CONNECTION ASSESSMENT & APPROVAL PROCESS

Preliminary Assessment Report

Project: *Reactive Compensation at Wawa TS*

New Reactive Compensation at Wawa TS

Figure 2 Wawa TS - Proposed 13.8 kV facilities for Alternative # 1

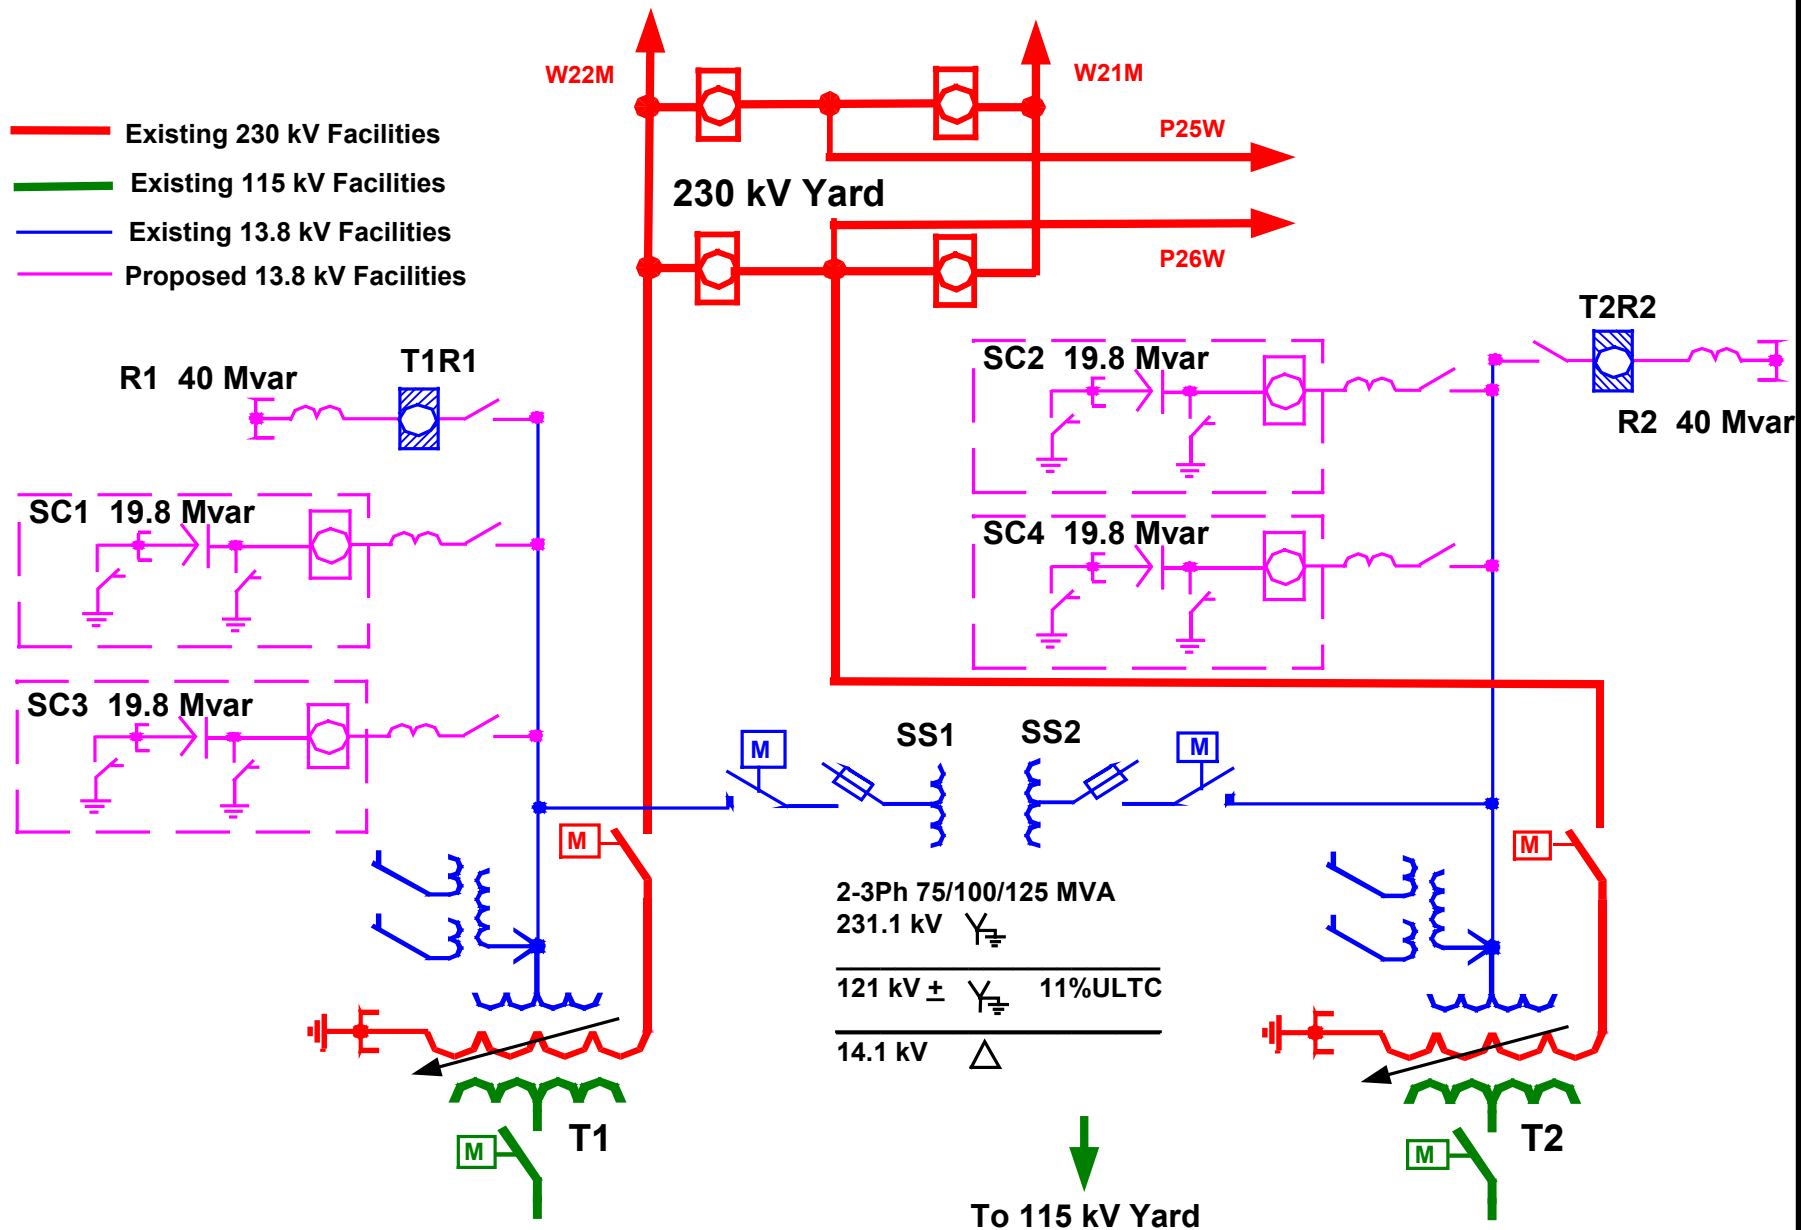
It is concluded that the two 39.6 Mvar shunt capacitors meet the Market Rule requirements with respect to voltage changes for switching operations. In order to obtain higher flexibility in controlling the operating voltage at Wawa TS, the IMO prefers that Hydro One install two smaller banks (i.e. 19.8 Mvar) on the tertiary of one of the Wawa TS autotransformer. Hydro One Networks has indicated that they have considered the alternative arrangement of installing two smaller banks (i.e. 19.8 Mvar) on the tertiary of one of the Wawa TS which as suggested by IMO, but they concluded that the proposed 2 x 39.6 Mvar arrangement is the most cost-effective arrangement.

Figure 3 Wawa TS - Proposed 13.8 kV facilities for Alternative # 2

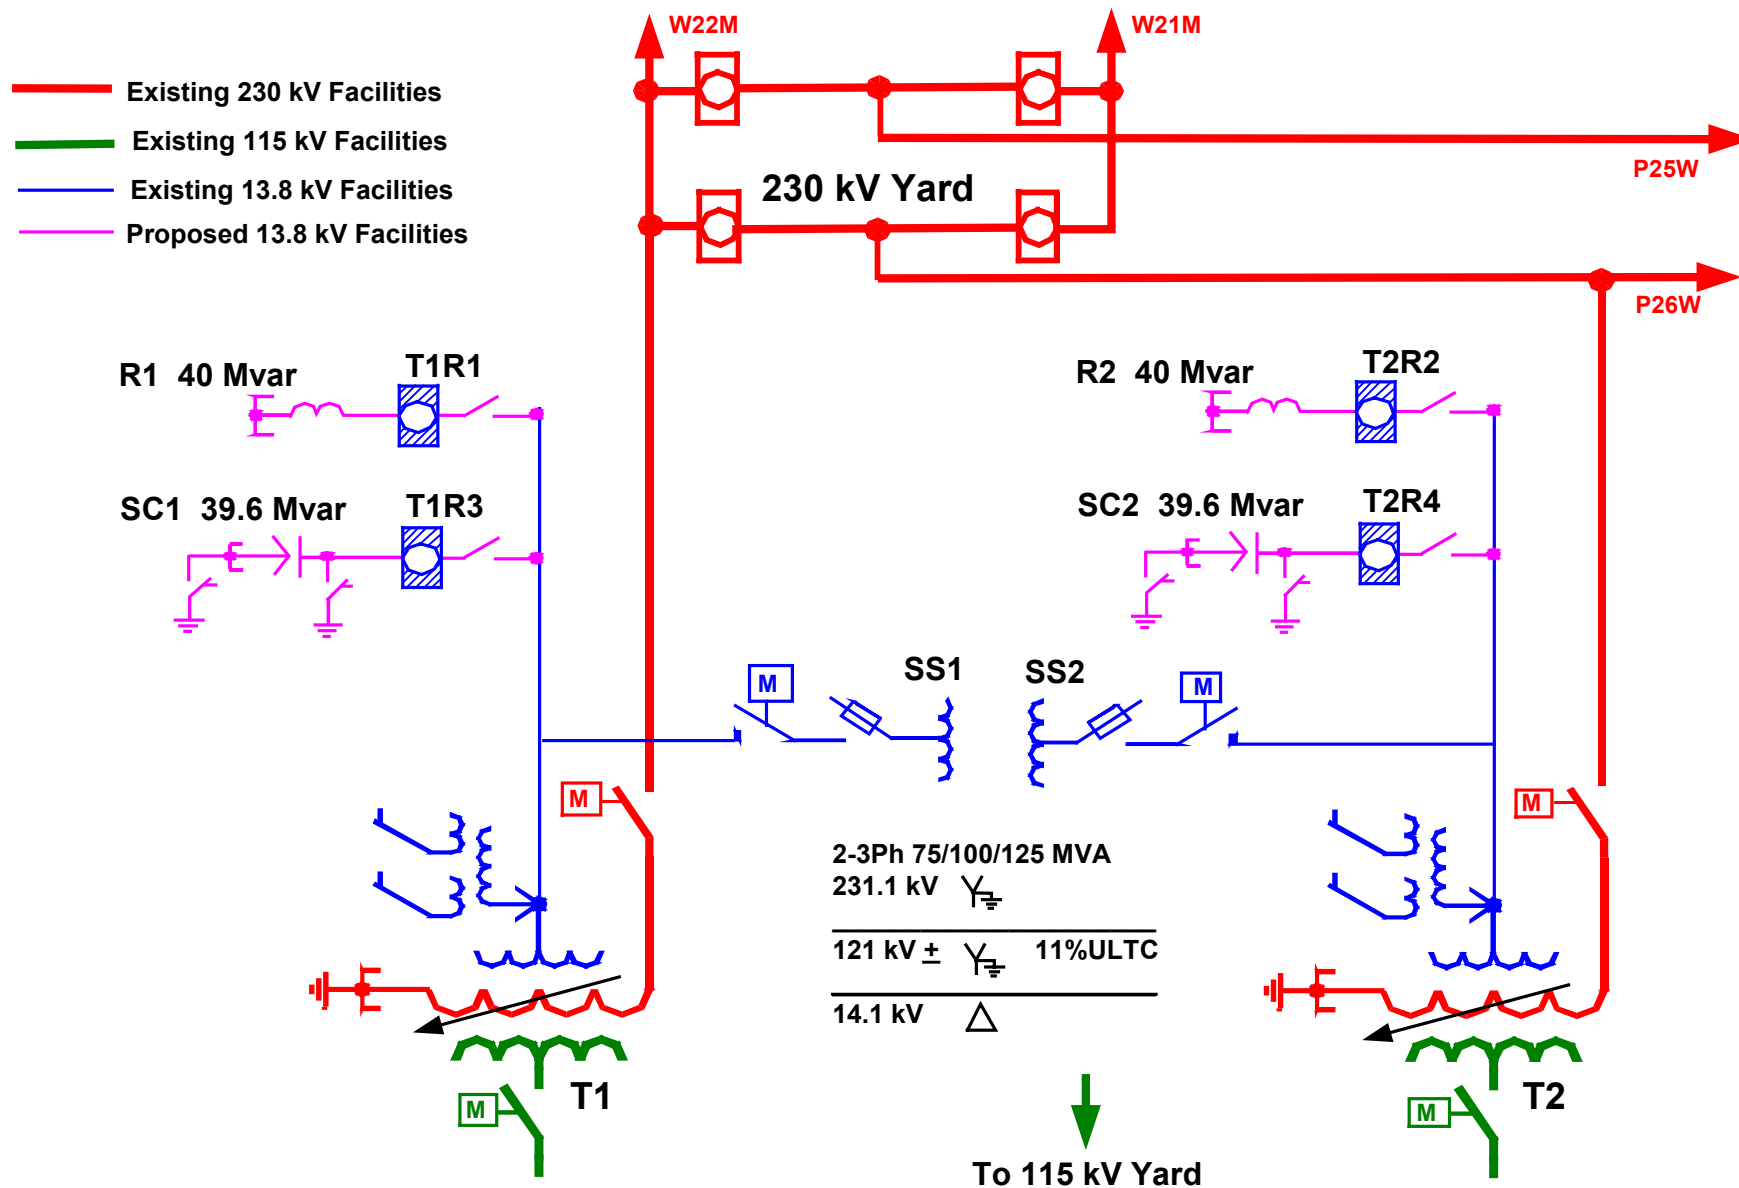
Under Alternative 2, it is proposed to reuse all four existing circuit breakers for connecting the new shunt reactors and capacitors. Hydro One Networks Inc. should ensure that the existing breakers are adequately rated for switching the new equipment.

The IMO has noted that more operating flexibility could be achieved if one of the planned shunt capacitors would be composed of 2x19.8 Mvar banks. Hydro One Networks has considered the alternative arrangement of installing two smaller banks (i.e. 19.8 Mvar) on the tertiary of one of the Wawa TS but they concluded that the proposed 2 x 39.6 Mvar arrangement is the most cost-effective arrangement.

IMO requires that the new shunt capacitor banks and the new shunt reactors be switched off automatically when Wawa voltage is too high or too low respectively.
